# UNITED STATES PATENT AND TRADEMARK OFFICE

APPLICATION NO.	FILING DATE	FIRST NAMED INVENTOR	ATTORNEY DOCKET NO.	CONFIRMATION NO.
10/605,852	10/30/2003	Martin Weiss	20073	2851

<b>Office Action Summary</b>	Application No.	Applicant(s)	
	10/605,852	WEISS, MARTIN	
	Examiner	Art Unit	
	Vinh T. Luong	3682

Fig. 5

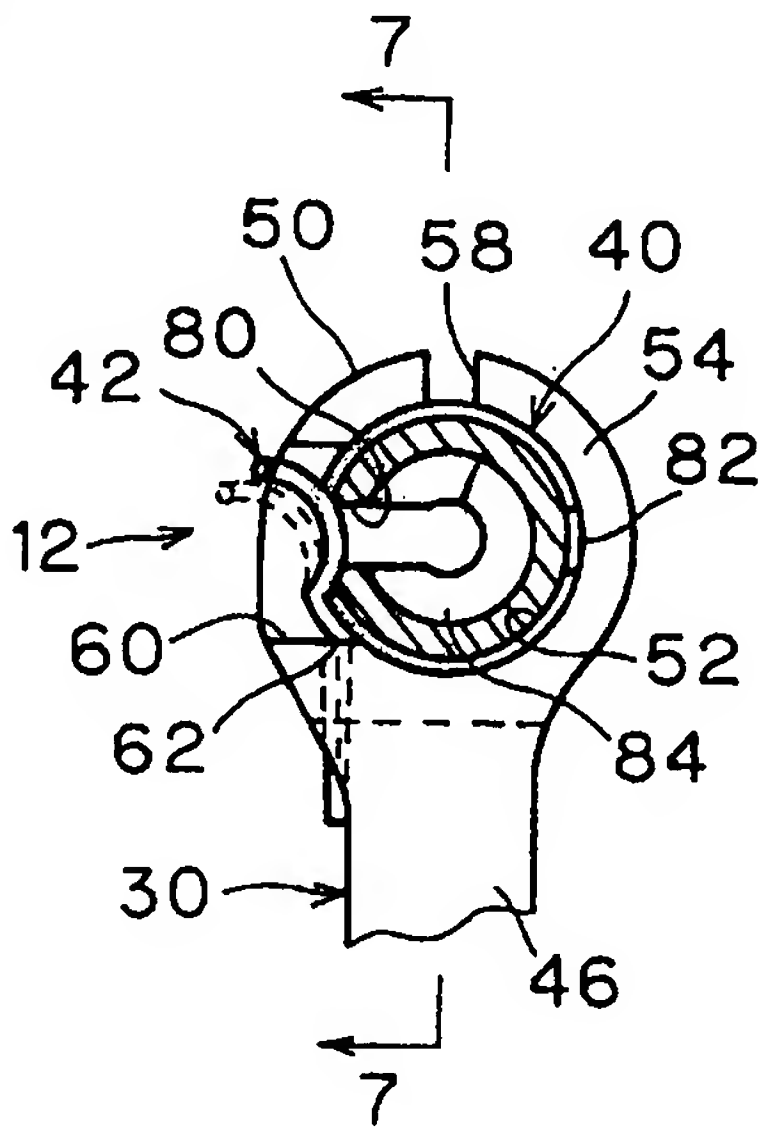
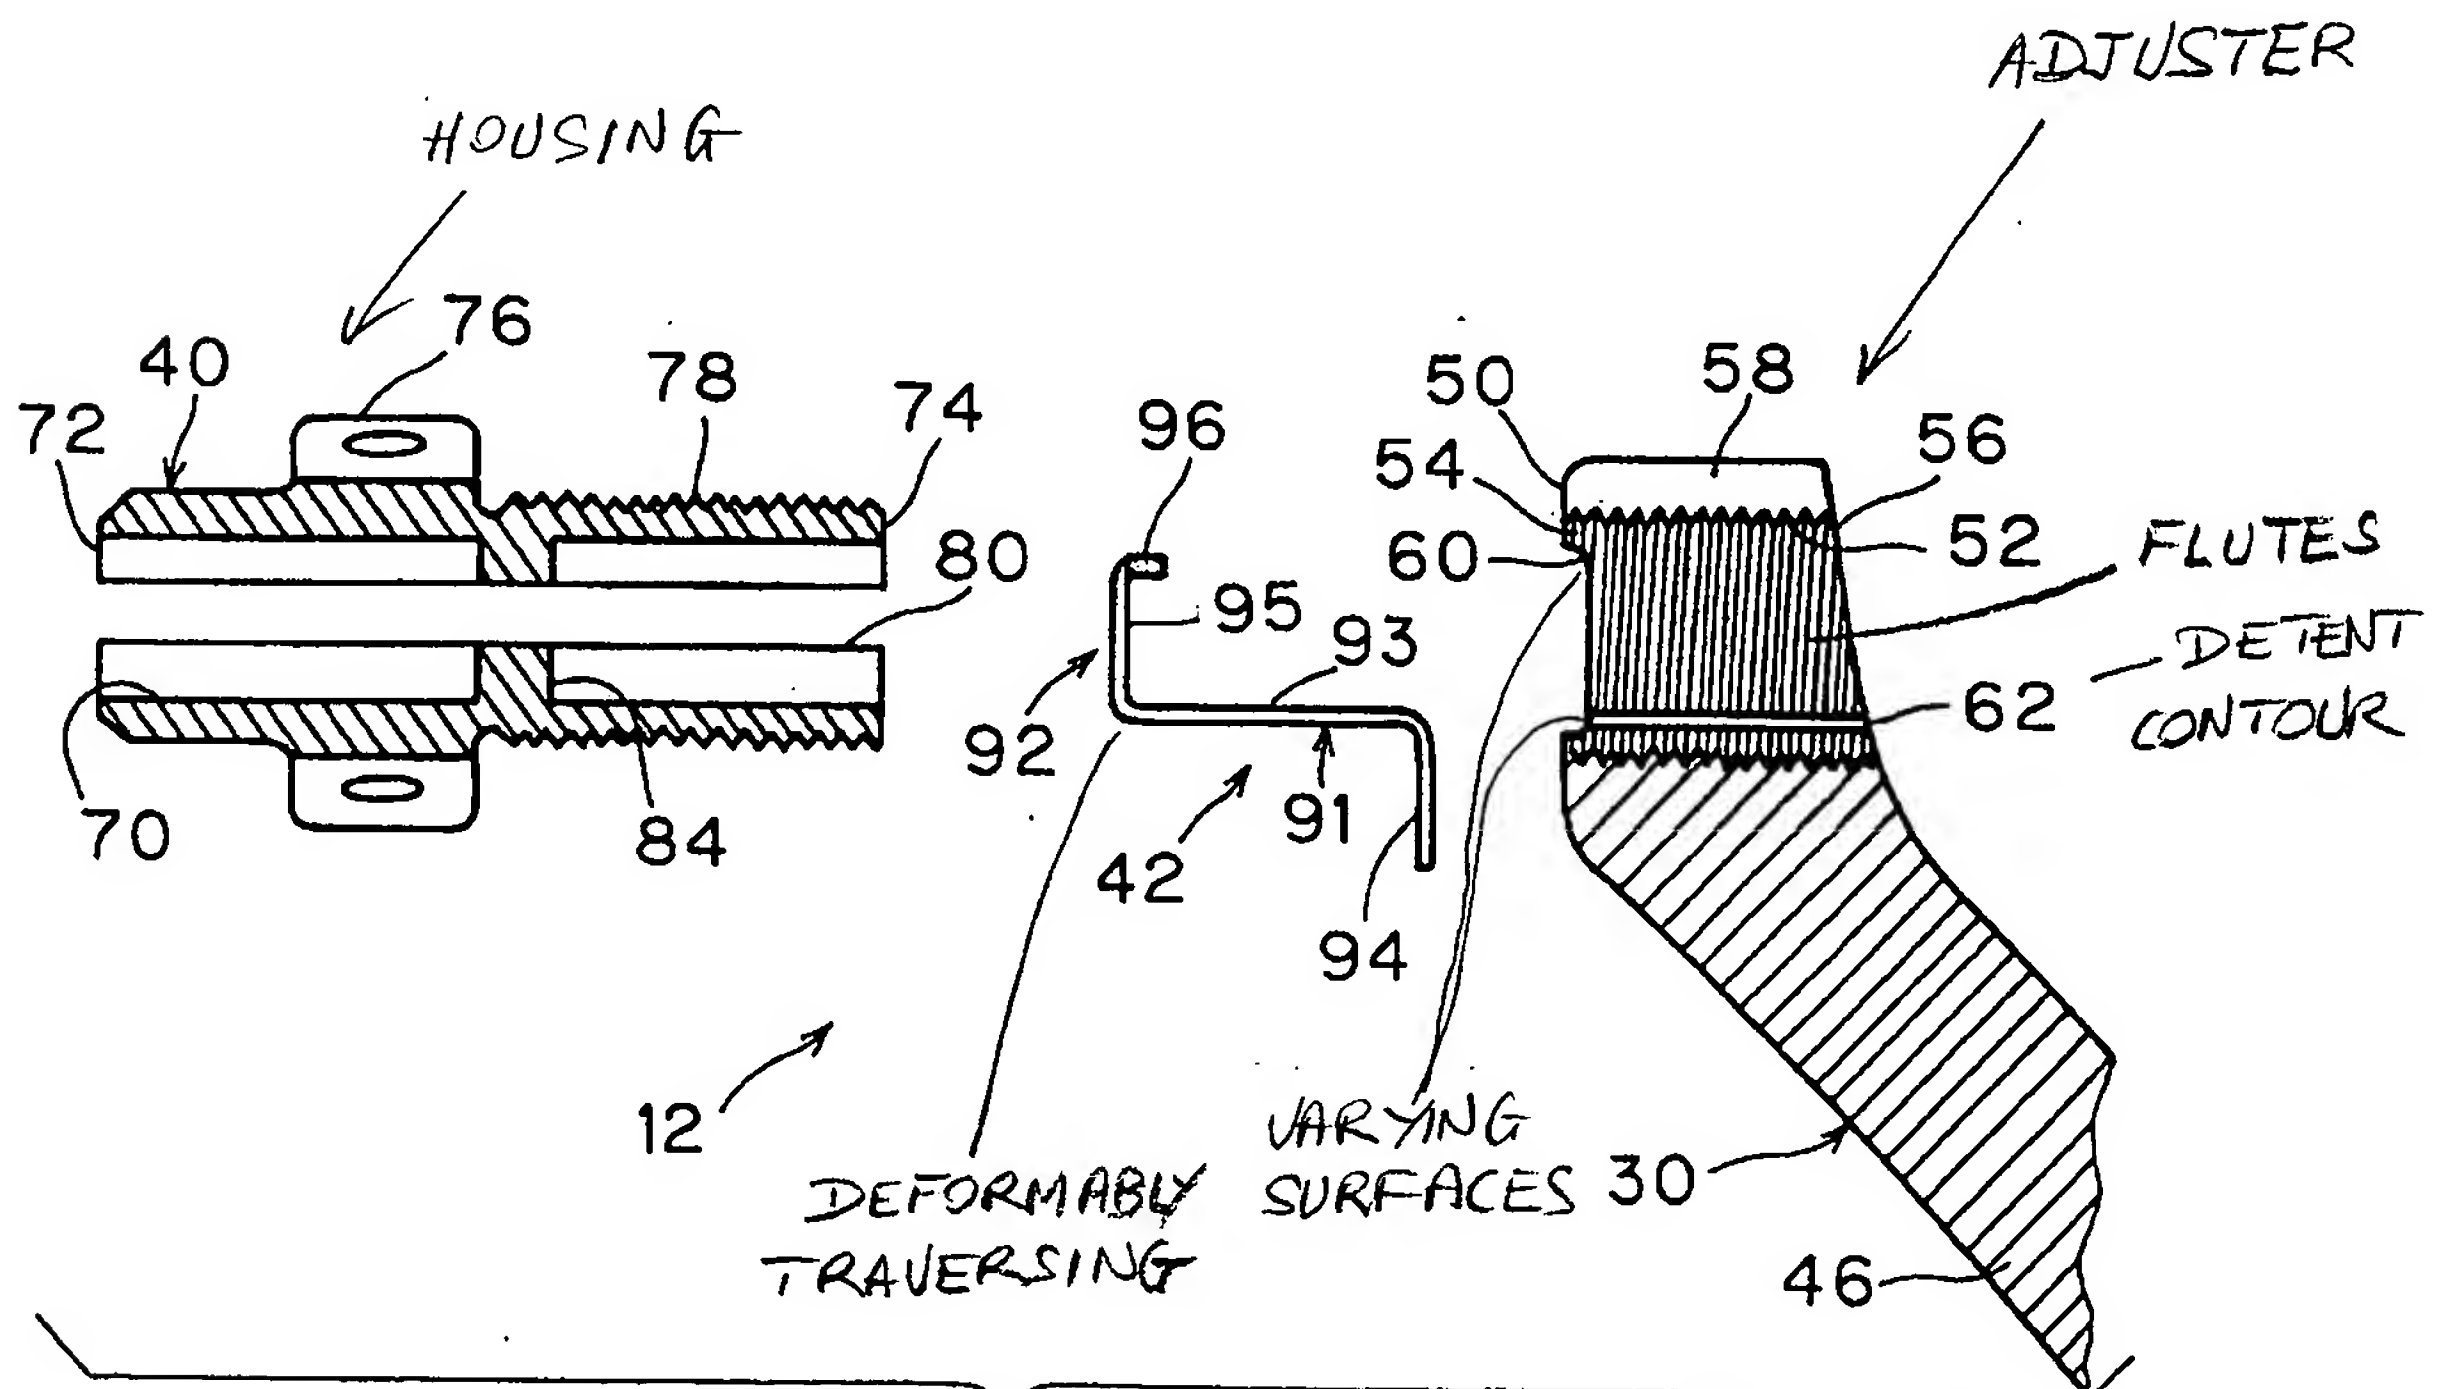
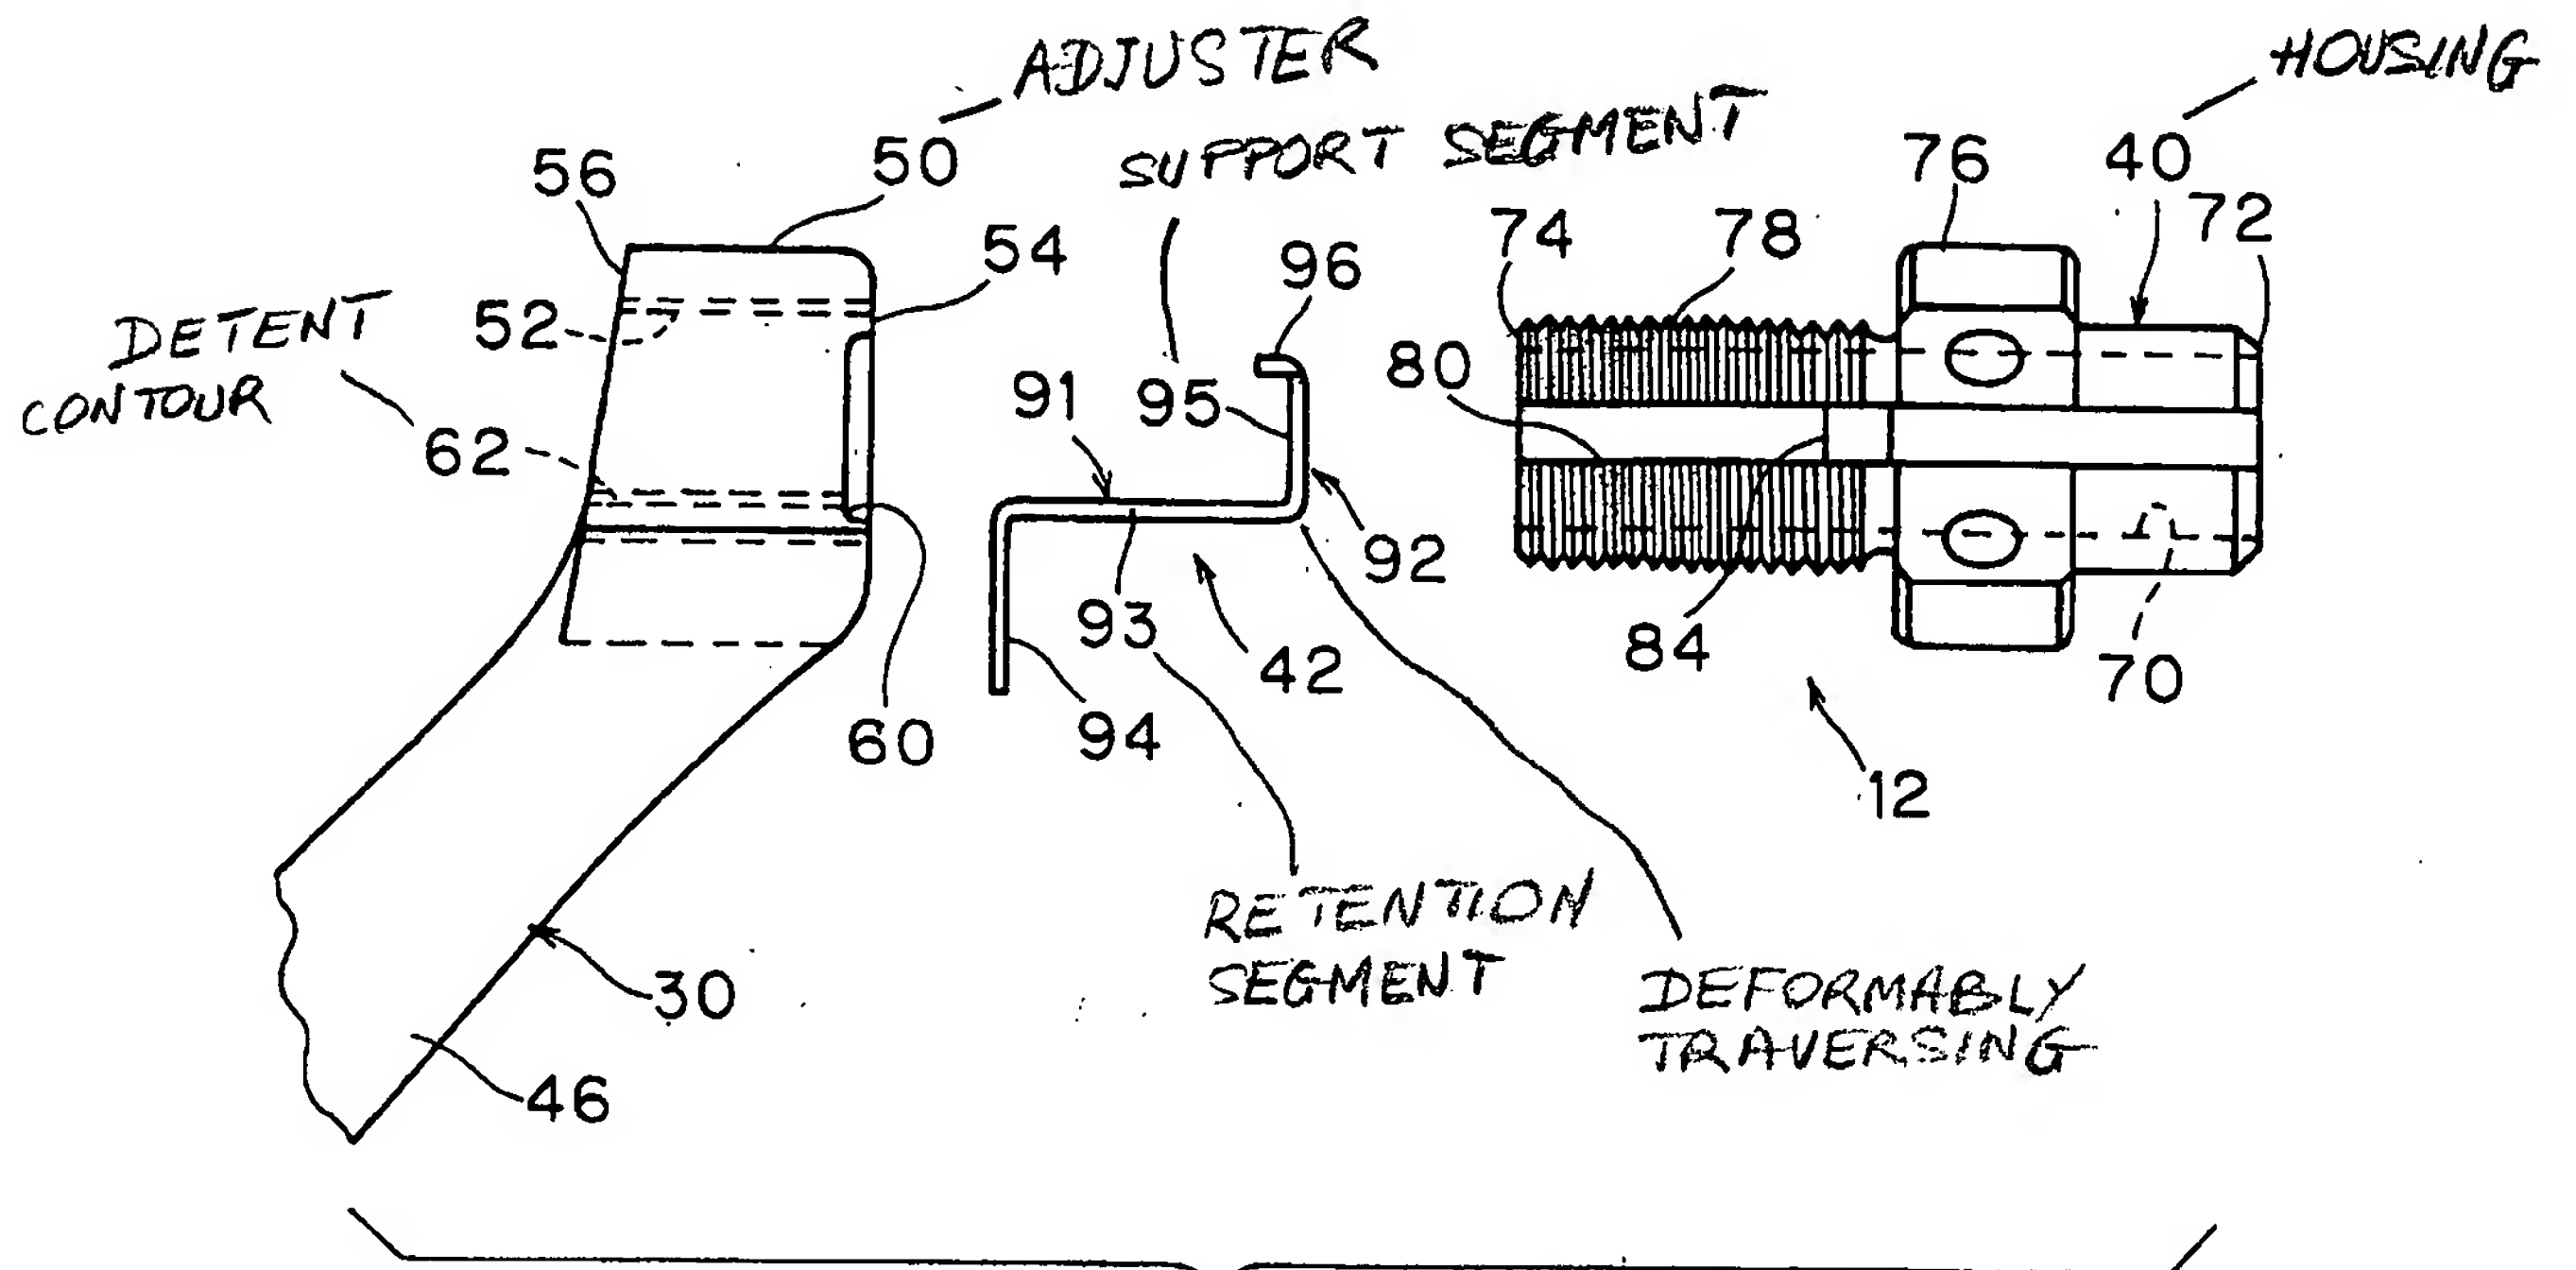
a detent mechanism including a detent contour 62 (*id.* col. 5, line 56 through column 6, line 24) extending along a radial interior surface (Figs. 4-7) of the adjuster 50 and a spring element 42 having at least one retention segment 93 and a support segment 95, the retention segment 93 of the spring element 42 *deformably traversing along* the detent contour 62 (at its bent portion as best seen in Fig. 4 of the Attachment. *Ibid.* col. 6, lines 14-34), the support segment 95 of the spring element 42 supported by the housing 40 (Fig. 5).

The Examiner respectfully submits that Applicant's contention is unsupported by the substantial evidence in the record. In fact, Yamashita teaches the element 50 that has a detent contour 62 wherein the retention segment 93 of the spring 92 engages the contour 62 *from within* the element 50. Moreover, one end of the retention segment 93, which is connected with the support segment 92/95, is bent transversely to the detent contour as seen in Figs. 4 and 5 so that
